ORDINANCE NO. _____

An ordinance amending Chapter 57, “Dallas One-and Two-Family Dwelling Code,” of the Dallas City Code, as amended; adopting with certain changes the 2021 Edition of the International Residential Code of the International Code Council, Inc.; regulating the construction, enlargement, alteration, repair, demolition, use, and maintenance of construction, plumbing, mechanical, and electrical work in the city on one- and two-family dwellings; providing a penalty not to exceed \$2,000; providing a saving clause; providing a severability clause; and providing an effective date.

Figure 307.4

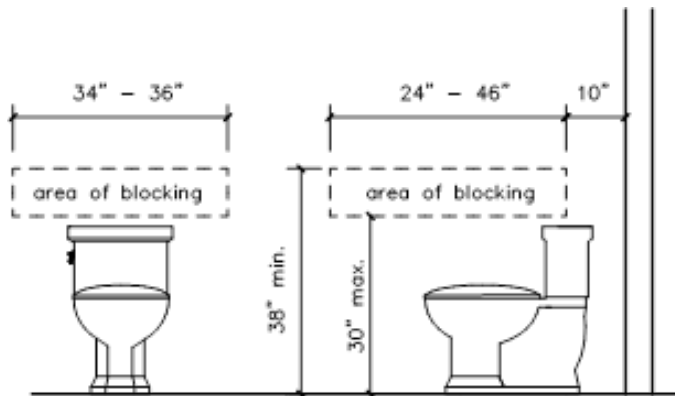
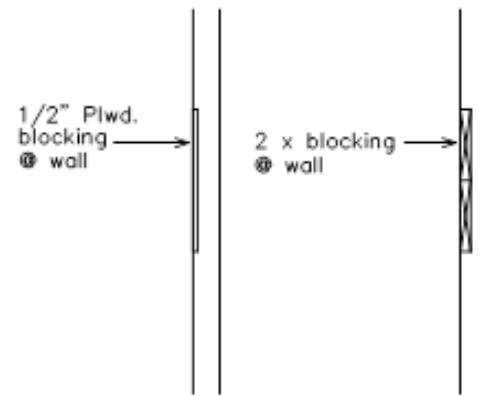
R307.3 When blocking is required. Required at one toilet at grade level. Blocking per Section R307.4 and Figure 307.4 shall be installed at rear wall and one wall adjacent to toilet at the lowest living level where a toilet is provided.

R307.4 Blocking dimensions and materials. Blocking may be 1/2" plywood or equivalent or 2 x solid wood blocking flush with wall.

**“FIGURE R602.6.1
TOP PLATE FRAMING TO ACCOMMODATE PIPING**

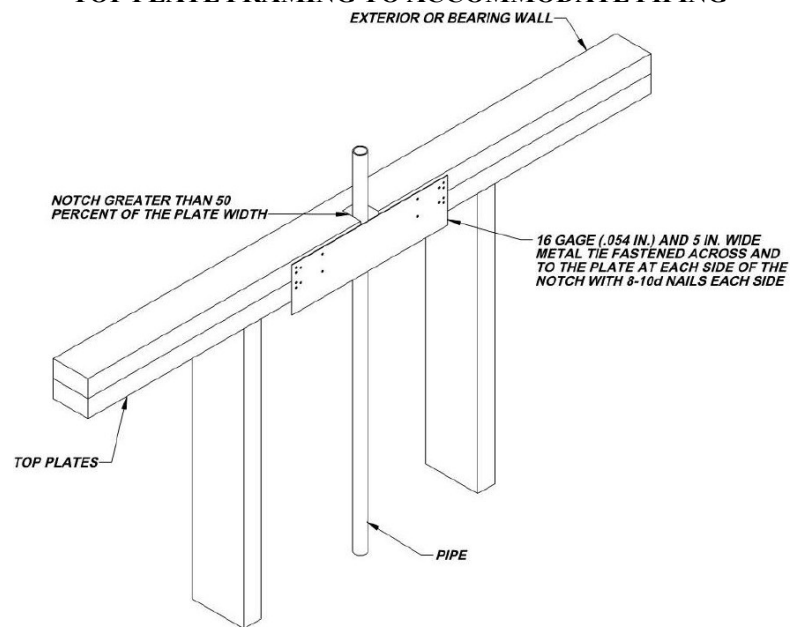
“R602.6.1 Drilling and notching of top plate. Where piping or ductwork is placed in or partly in an exterior wall or interior *load-bearing wall*, necessitating cutting, drilling or notching of the top plate by more than 50 percent of its width, a galvanized metal tie not less than 0.054 inch thick (1.37 mm) (16 ga) and 5 [4½] inches (127 [38] mm) wide shall be fastened across and to the plate at each side of the opening with not less than eight 10d (0.148 inch diameter) nails having a minimum length of 1½ inches (38 mm) at each side or equivalent. Fasteners will be offset to prevent splitting of the top plate material. The metal tie must extend a minimum of 6 inches past the opening. See Figure R602.6.1.

27. Figure R602.6.1, “Top Plate Framing to Accommodate Piping,” of Subsection R602.6, “Drilling and Notching of Studs,” of Section R602, “Wood Wall Framing,” of Chapter 6, “Wall Construction,” of Part III, “Building Planning and Construction,” of the 2021 International Residential Code is deleted and replaced with a new Figure R602.6.1, “Top Plate Framing to Accommodate Piping,” to read as follows:
